RBI Futera III Series Firmware Revision Sheet

Revision 3.51- 3.52   4-24-2015   Release

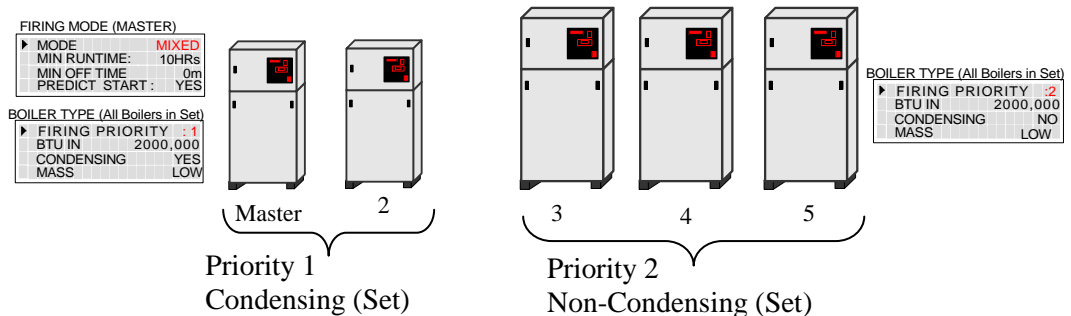
1. The first feature: A MIXED boiler priority method may be used to control condensing and non-condensing, base load, or other boiler **sets** in a system for optimal performance and economy. A boiler set can be constructed by simply setting the FIRING PRIORITY on each boiler (to be in the set) at the same priority. Setting all (example)condensing boilers to the highest priority of 1, and then setting all (example)non-condensing boilers to a priority of 2, will create (2) sets of boilers, one condensing and the other non-condensing. Once this is done, the set of condensing boilers will have a firing order that has a higher priority and is independent of the other non-condensing set with the lower priority. The boiler set with the highest priority can then be fired based on the conditional settings menu. The lower priority set will follow.

A boiler's firing priority can be designated as such in: "ADVANCED SETUP:SYSTEM:BOILER TYPE:FIRING PRIORITY : 1" menu on each boiler. A priority of '1' is the highest priority, a '2' the lowest (default is always 2).

In the above example condensing boilers and non-condensing boilers are used, but other combinations may also be used. Another example could use (2) small boilers and set them to Priority 1 and then use (3) large boilers and set them to Priority 2. Using these priority settings (with the conditions menu), the small boilers can run first during the shoulder months and the larger boilers can fire last during the colder season (base loading set).

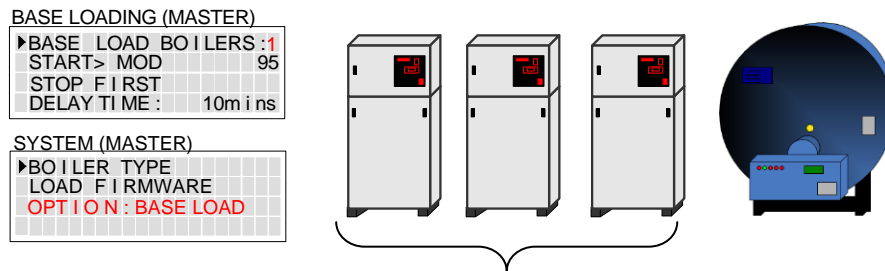
Starting Boilers:
When a boiler is to be fired (water temp is below the heating band), the Master checks the Heat Net boilers it has available. The Master boiler then looks at which boilers are returning priority firing status (set on a boiler in: (ADVANCED SETUP:SYSTEM:BOILER TYPE:PRIORITY : *1*). If the Start condition is met (ADVANCED SETUP:FIRING MODE: MODE: MIXED:SET *FIRS T*(*example*), the Master or Member boiler that is configured as PRIORITY 1, with the lowest runtime, will be fired *FIRST*(*example*).. As long as the start condition is met, all PRIORITY 1 set of boilers will fire based on runtime. Once all PRIORITY 1 set of boilers have fired, the PRIORITY 2 set of boilers will fire based on runtime. If the Start condition changes and/or is not met (such as with: OA T or RET temp), the PRIORITY 2 set of boilers will fire first/next based on runtime.

Stopping Boilers:
When a boiler is to be stopped (water temp is above the heating band), the Master checks the Heat Net boilers it has available. The Master boiler then looks at which boilers are returning priority firing status (set on a boiler in: (ADVANCED SETUP:FIRING MODE: MODE: MIXED:SET *LAST*(*example*) If the Stop condition is met, the Master or Member boiler that is configured as PRIORITY 1 with the highest runtime will be stopped *LAST* (*example*). As long as the stop condition is met, all remaining PRIORITY 1 set of boilers will stop based on runtime. If the Stop condition changes and/or is not met (such as with: OA T or RET temp), the PRIORITY 2 set of boilers will stop first/next based on their highest runtime.
